**DOCUMENT 00 90 00
ADDENDUM**

ADDENDUM NO. [1] Date: August 14, 2019

**RE: LANESBORO PUBLIC SCHOOLS
 ADDITION AND REMODEL
 100 KIRKWOOD ST EAST
 LANESBORO, MN 55949
 HSR 18063**

**FROM: HSR Associates, Inc
 100 Milwaukee Street
 La Crosse, WI 54603
 (608) 784-1830**

C100

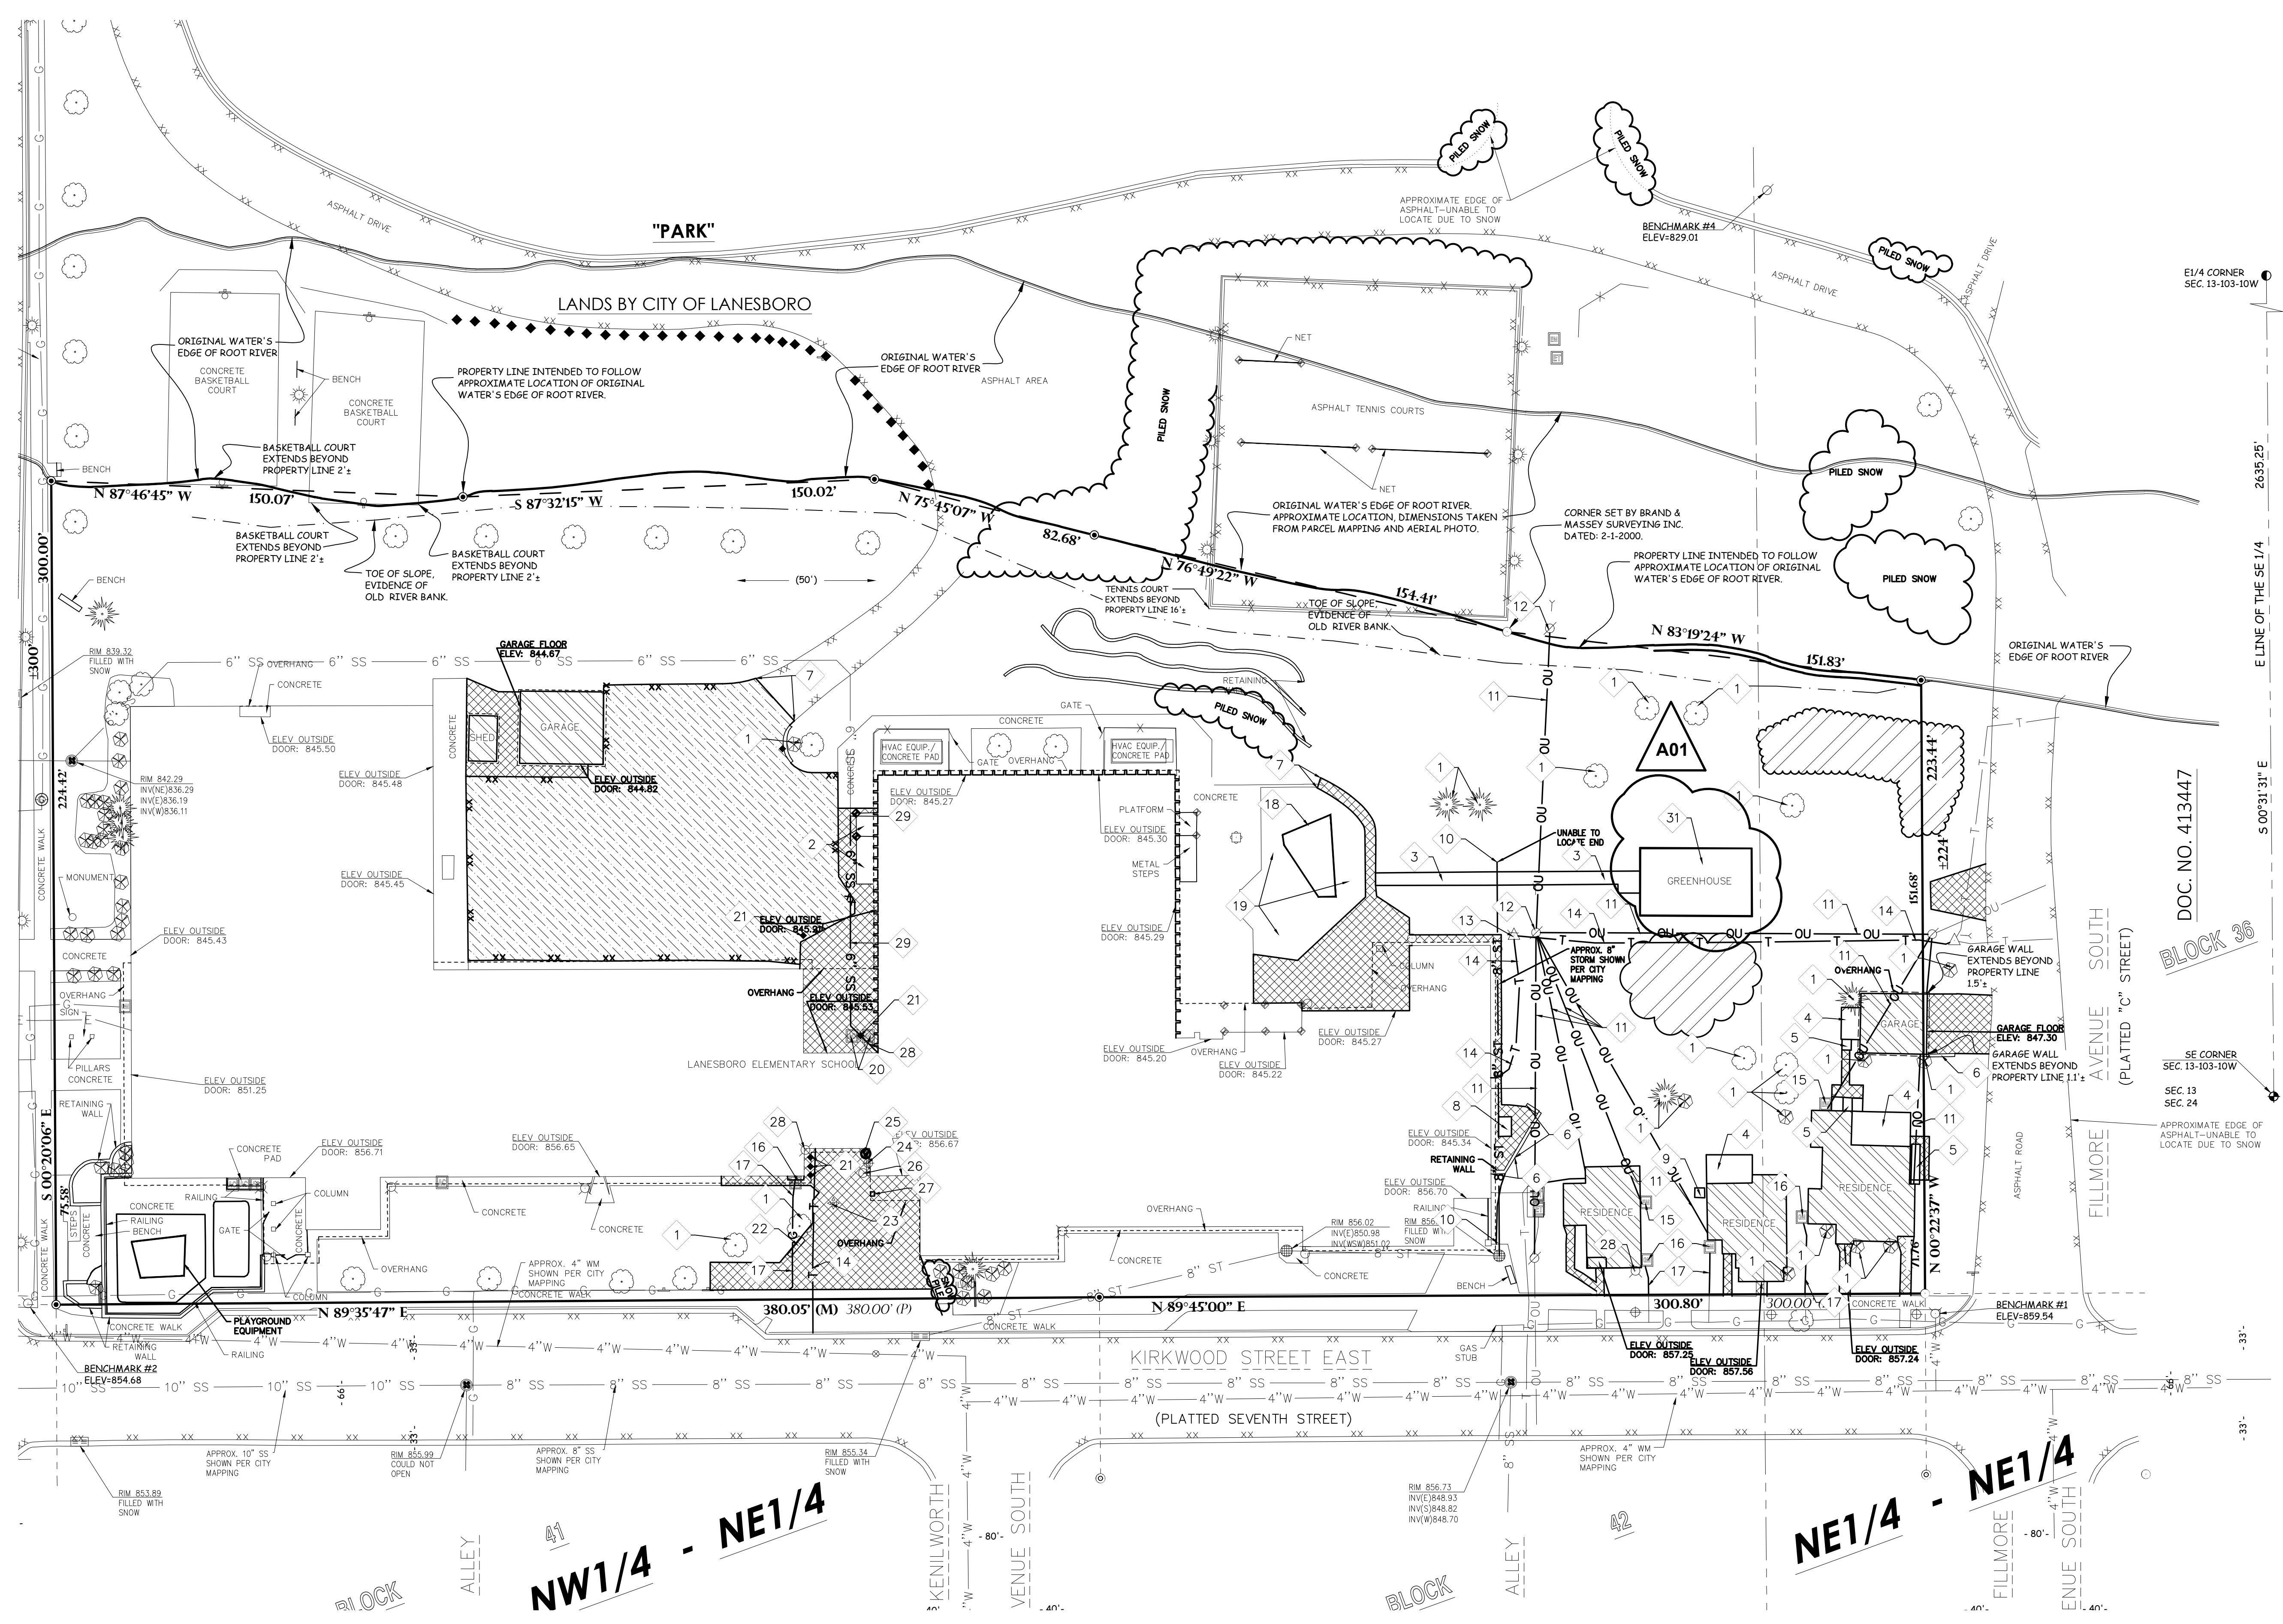
16. Sheet C100 DEMOLITION PLAN 30 x 42 attached hereto

- a. Revisions clouded on Drawing.

P094

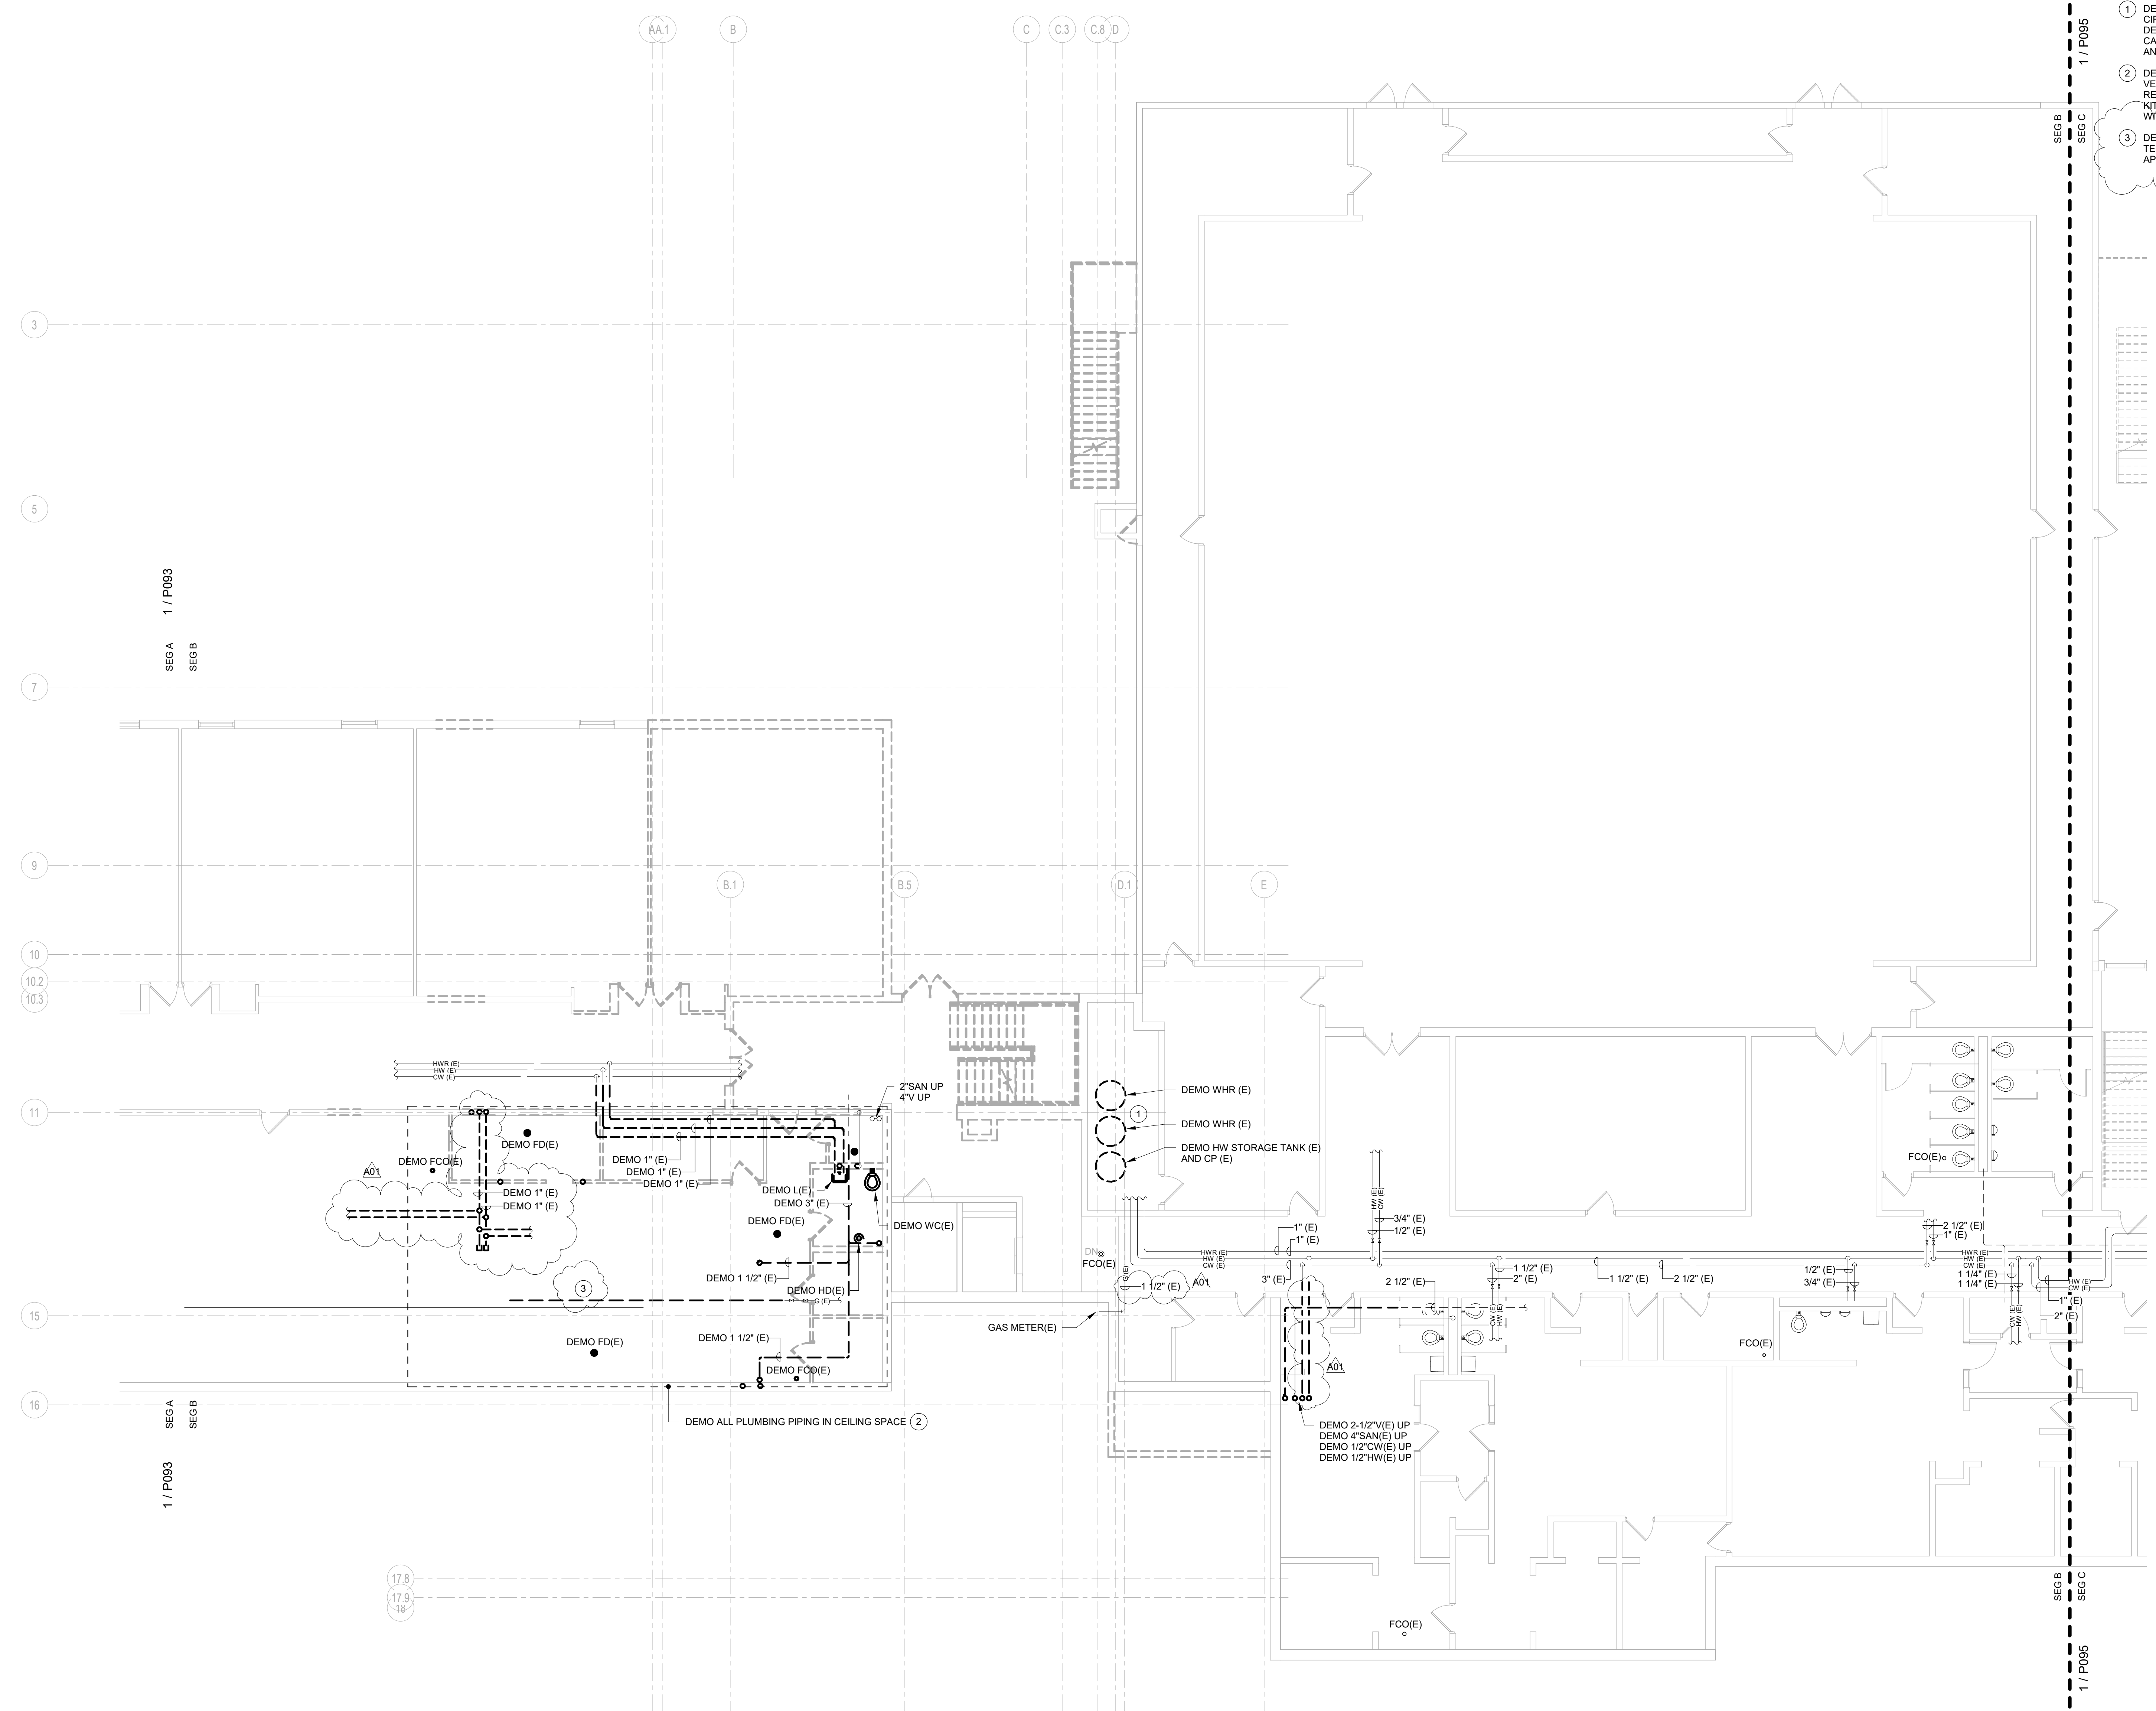
- e. Revise Pumps Schedule, as shown.
28. Sheet P094 LOWER LEVEL DEMO – SEGMENT B - PLUMBING 30 x 42 attached hereto
 - a. Revisions clouded on Drawing.

- b. Add piping to be demolished, as shown.
29. Sheet P097 UPPER LEVEL DEMO – SEGMENT B - PLUMBING 30 x 42 attached hereto
 - a. Revisions clouded on Drawing.

P097

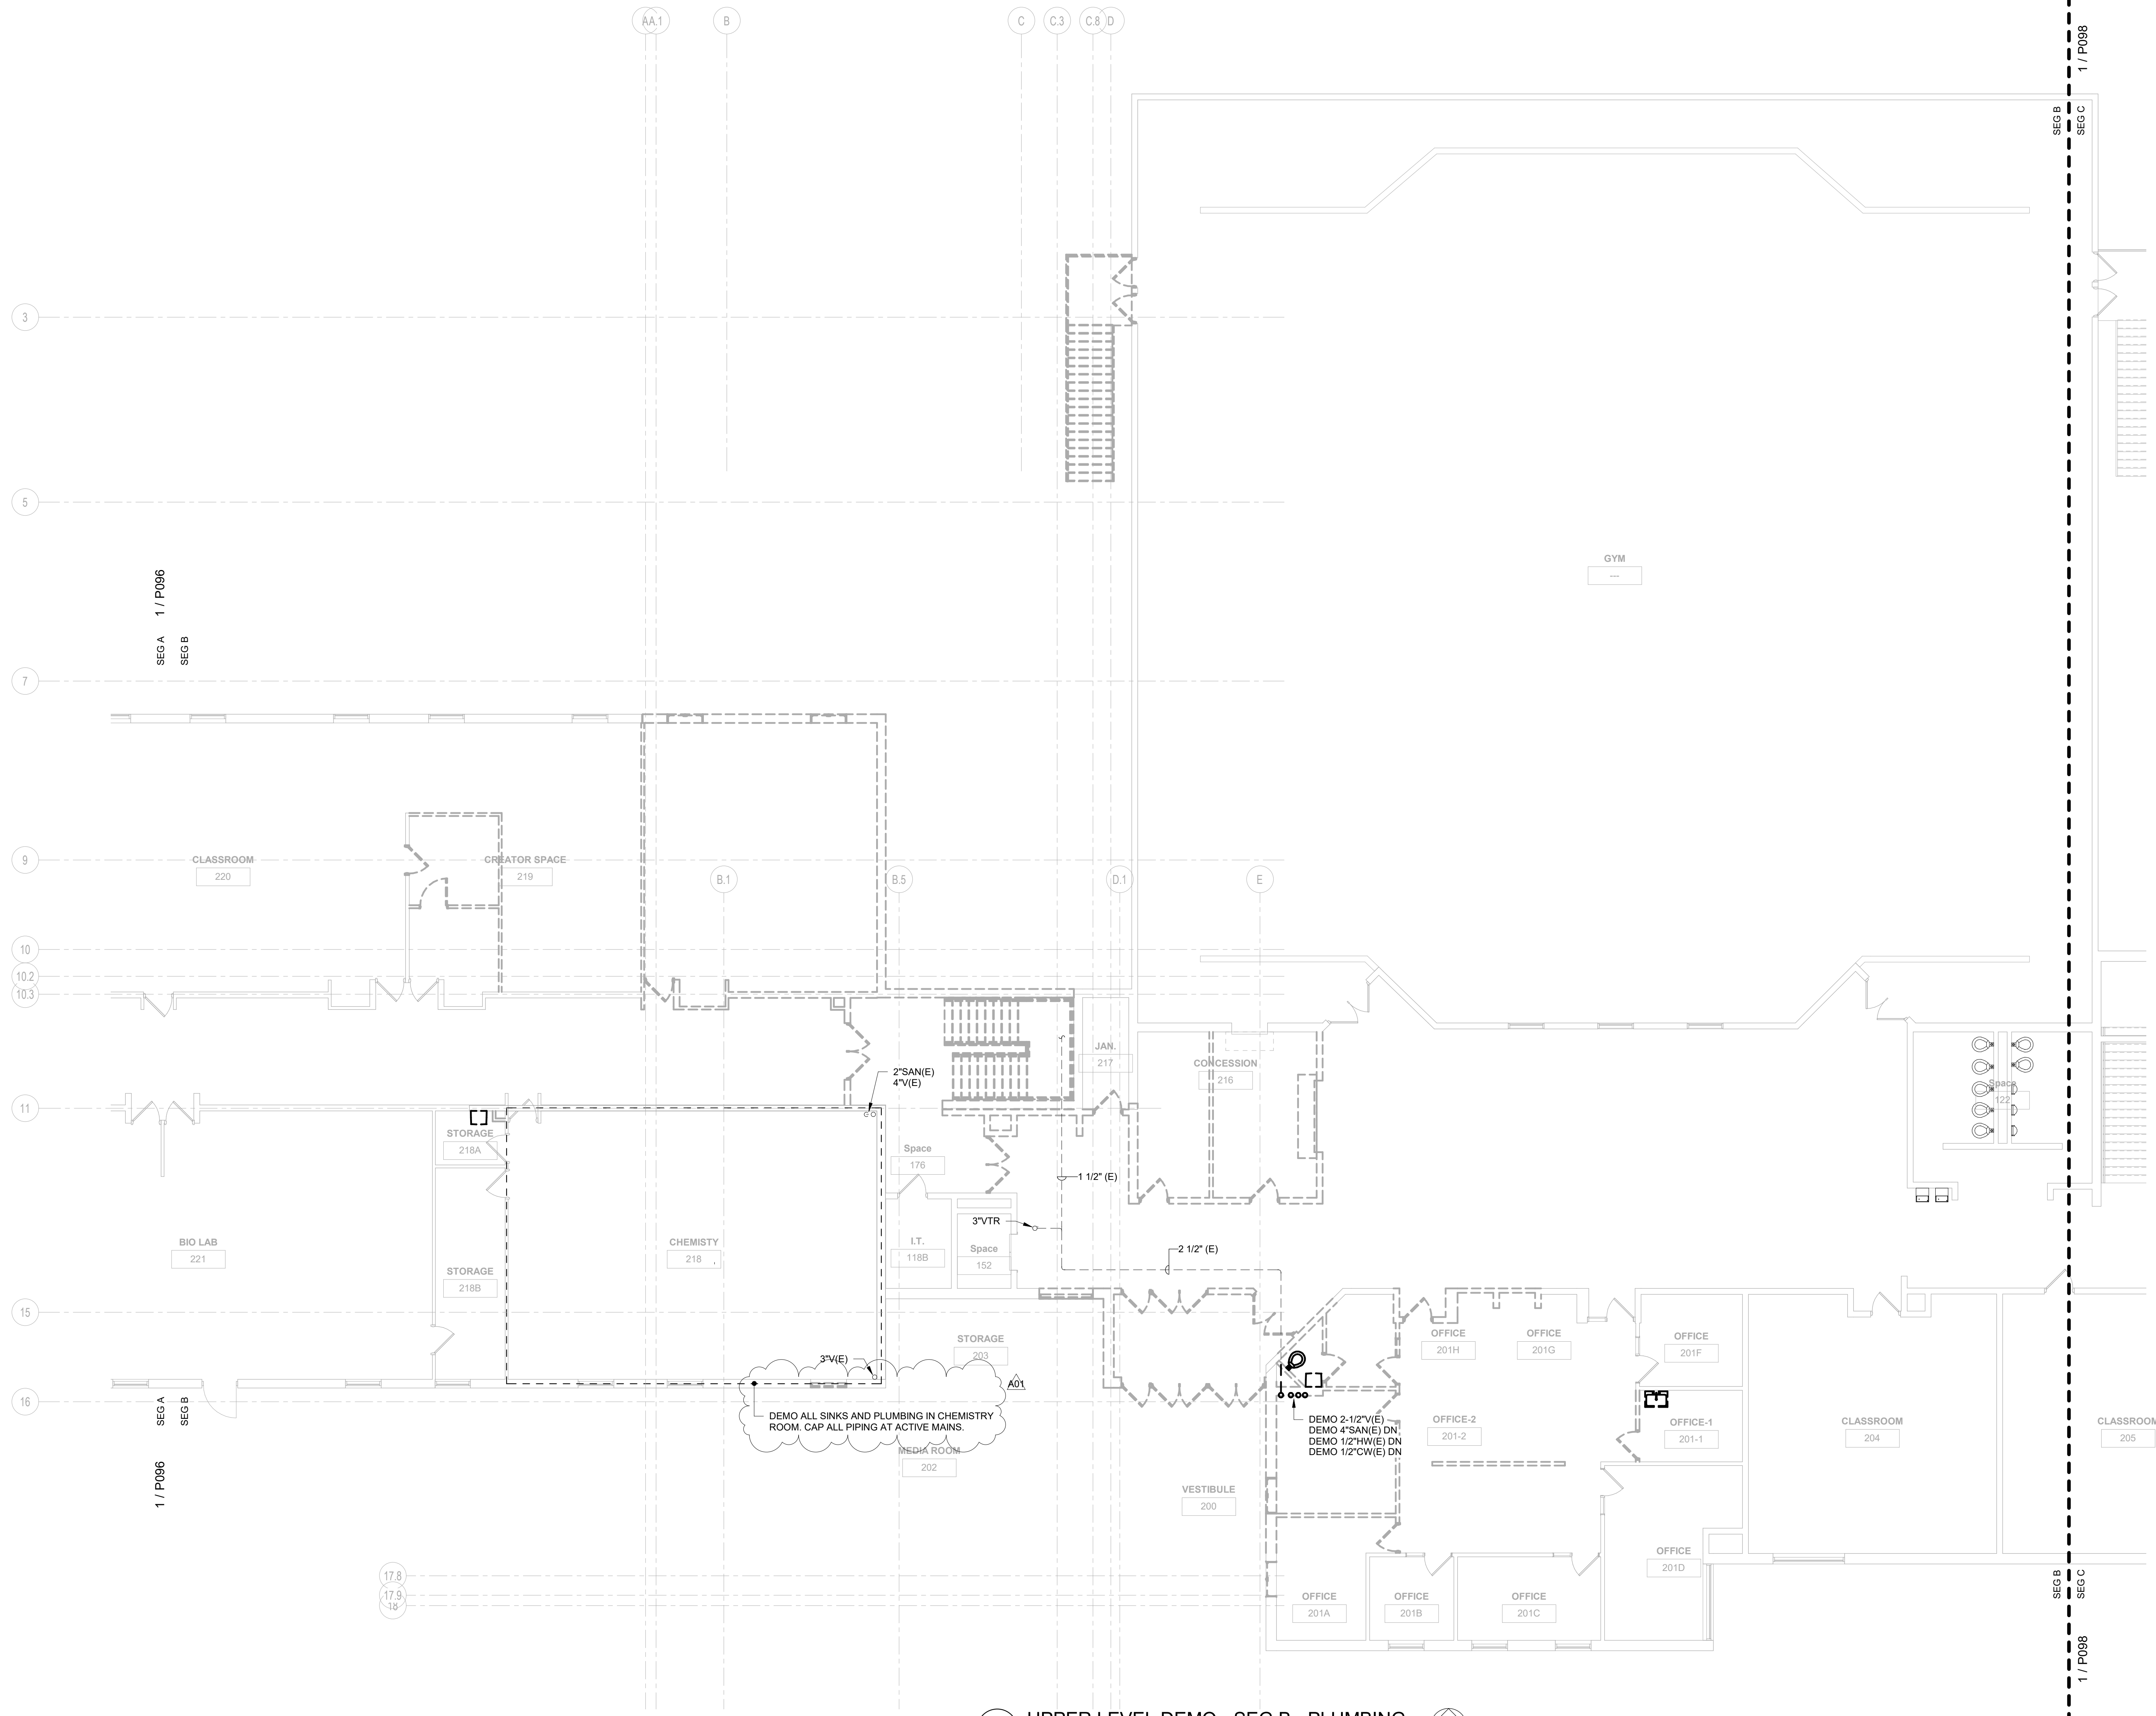
- b. Add note to cap piping at nearest active main, as shown.
 - c. Demolish sink in existing Storage room 218A.
30. Sheet P100 UNDERFLOOR – SEGMENT A – PLUMBING 30 x 42 attached hereto
